MCTC-20 Series

Appearance Change Notification

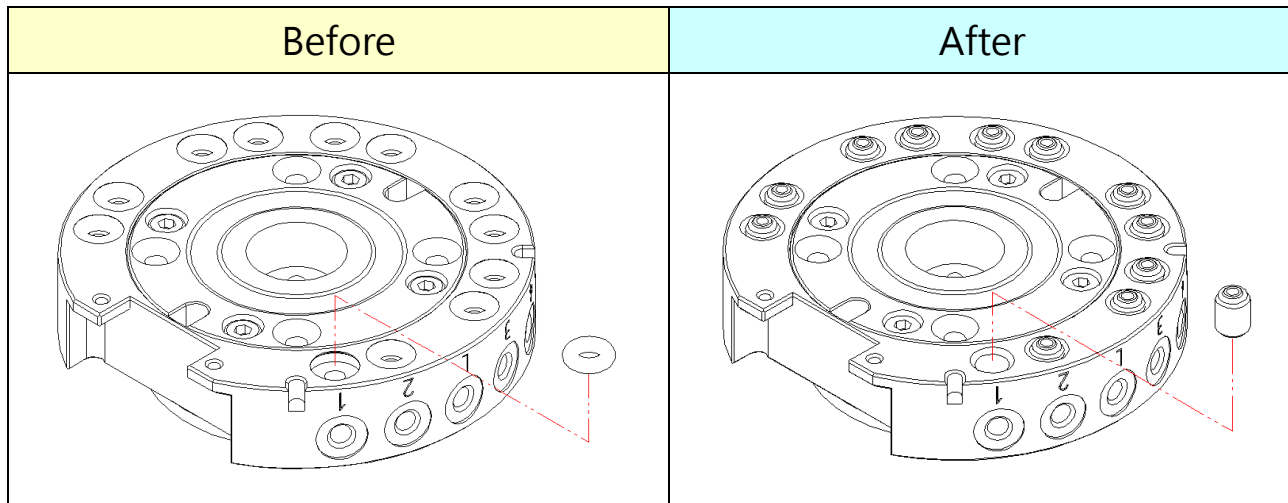
1. Model series
MCTC-20
2. Design change reason
Optimized seal design
3. Change descriptions
